Service Bulletin

SB 81438-XX-34-14

SUBJECT: 2000 Approach and 2000 Approach Plus GPS Approach Navigation System, Part Numbers 81438-XX-XXXX

Figure 1
Disassembly of 2000 Approach Chassis

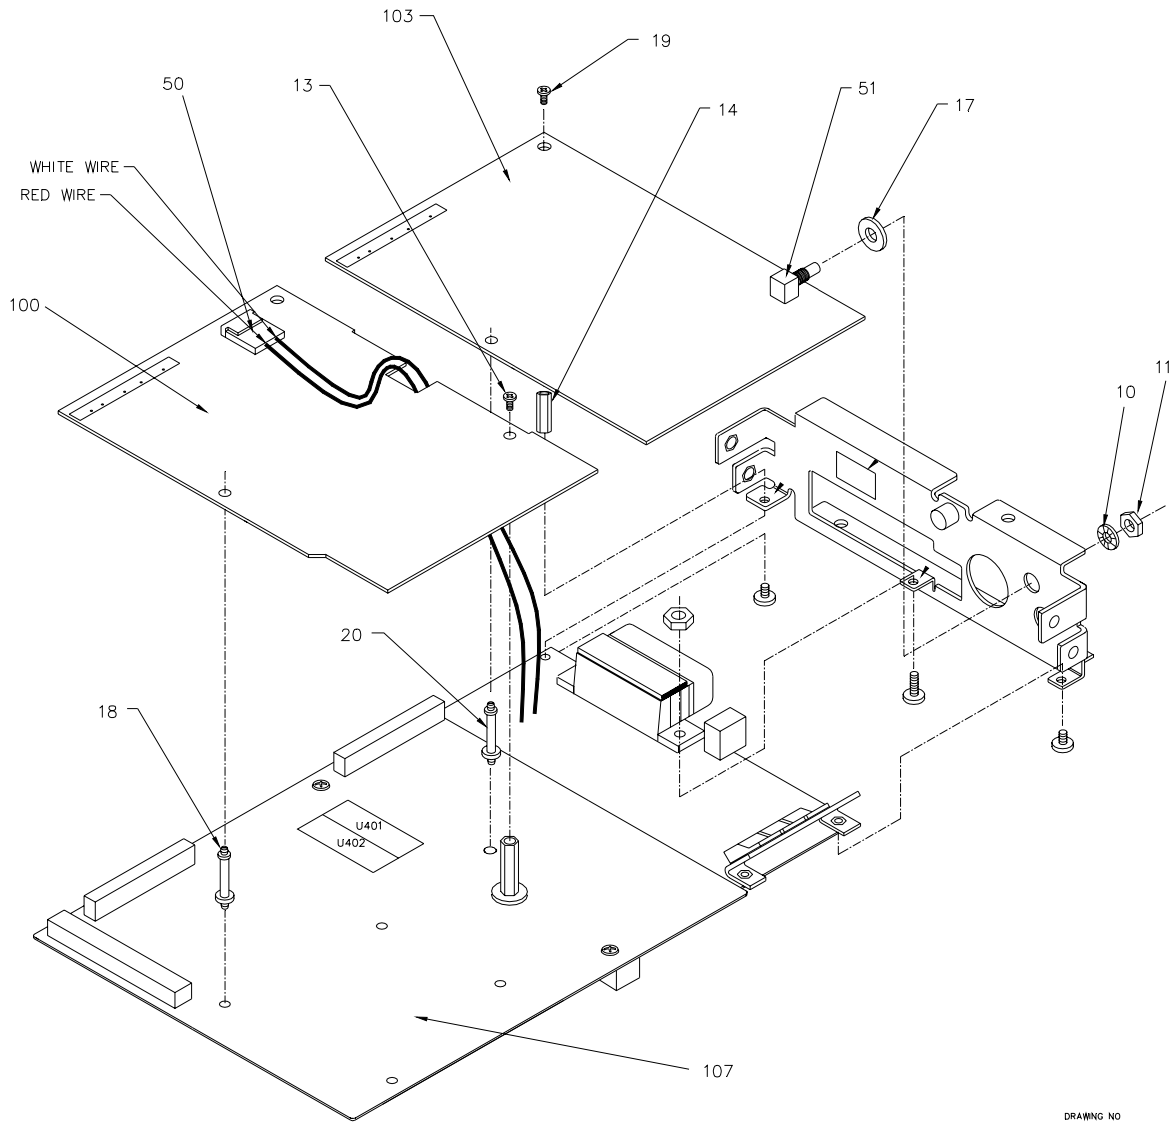
To replace the existing Processor Board (A6) CCA with a modified CCA, so unit will be capable of addressing a 4 MB database.

1. Place the unit on an anti-static mat.
2. Remove the NavData card if in the unit and place the card in an anti-static bag.
Refer to Figure 1.
3. Remove 2 screws (Item 15) from top.
4. Slide the top cover (Item 3) towards the rear and lift off cover.
5. Unscrew mounting shaft (Item 6) and carefully remove from unit taking care not to bring shaft into contact with components inside unit.
6. Remove 2 screws (Item 15) from bottom (Item 5). Slide bottom towards rear of unit and lift off.
7. Remove 8 screws (Item 16), 4 from each side. Remove side rails (Item 2).
8. Remove Display Assembly (Item 1) by pulling straight forward.

6. Install the side rails (Item 2). Attach the 2 screws (Item 16) to side rails at the rear.
7. Install the Display Assembly (Item 1), carefully inserting pins into connector.
8. Attach the 2 screws (Item 16) to side rails and Display Assembly (Item 1) at front.
9. Install the bottom cover (Item 5).
10. Attach 2 screws (Item 15) at rear of bottom cover.
11. Install the mounting shaft (Item 6), taking care not to bring it into contact with components inside the unit.
12. Install the top cover (Item 3) by sliding the front lip under the edge of the Display Assembly (Item 1).
13. Attach 2 screws (Item 15) at rear of top cover.

Figure 2
2000 Approach CCA Stack

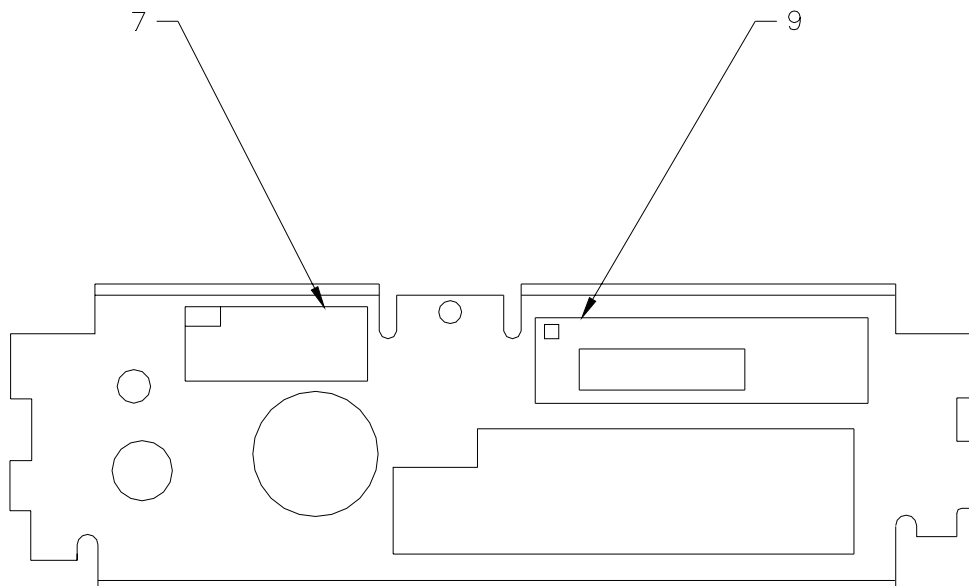
9. Remove nut (Item 11) and washer (Item 10) from antenna connector (Item 51).
10. To reduce the possibility of electric shock, discharge capacitors C9-C11.
11. Disconnect wires (Item 50) from connector on Power Interrupt CCA (Item 100).
12. Remove screw (Item 13) from the Power Interrupt CCA (Item 100).
13. Carefully lift Power Interrupt CCA, unsnapping standoff (Item 18) and unplugging 36-pin connector. Set aside.
14. Remove 1 screw (Item 19) from GPS sensor CCA (Item 103).
15. Lift front edge of GPS CCA (Item 103), unsnapping standoff (Item 20) and carefully unplugging pins from connector.

16. Remove the GPS CCA. Keep washer (Item 17) on antenna connector (Item 51).
17. Remove IOP/PWR SUPPLY CCA P/N 16227-21 (Item 107).

1. Install the GPS CCA (Item 103) on the IOP/PWR SUPPLY CCA P/N 16227-21 Rev B (Item 107). Ensure that washer (Item 17) is in place on the antenna connector (Item 51). Plug in 36-pin connector and snap onto standoff (Item 20).
2. Replace screw (Item 19) on GPS CCA (Item 103).
3. Bring red and white wires (Item 50) up between GPS CCA and Power Interrupt CCA (Item 100). Install Power Interrupt CCA, inserting 36-pin connector into P501. Snap onto standoff (Item 18).
4. Connect red and white wires (Item 50) to P4 on Power Interrupt CCA. (Verify that wires are oriented correctly.)
5. Replace screw (Item 13) on Power Interrupt CCA.

Figure 4
2000 Approach Plus Chassis

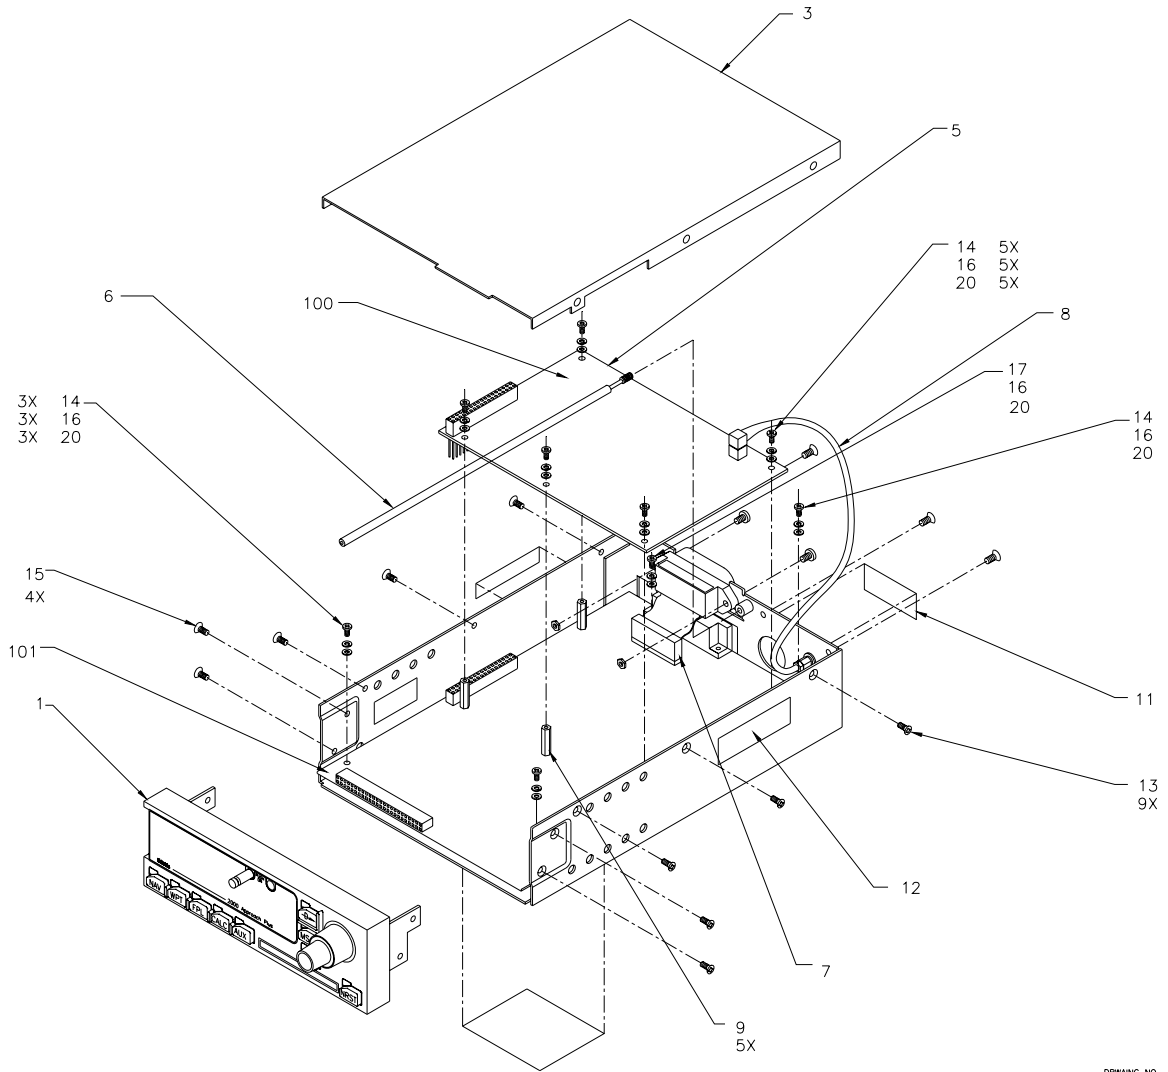
16. Remove 5 standoffs (Item 9) from IOP CCA (Item 101).
17. Remove 3 screws (Item 14) and washers (Items 16 and 20) from IOP CCA (Item 101).
18. Remove IOP CCA P/N 82477-00-Rev B (Item 101).

1. Replace IOP CCA, PN 82477-01-Rev B (Item 101), in unit.
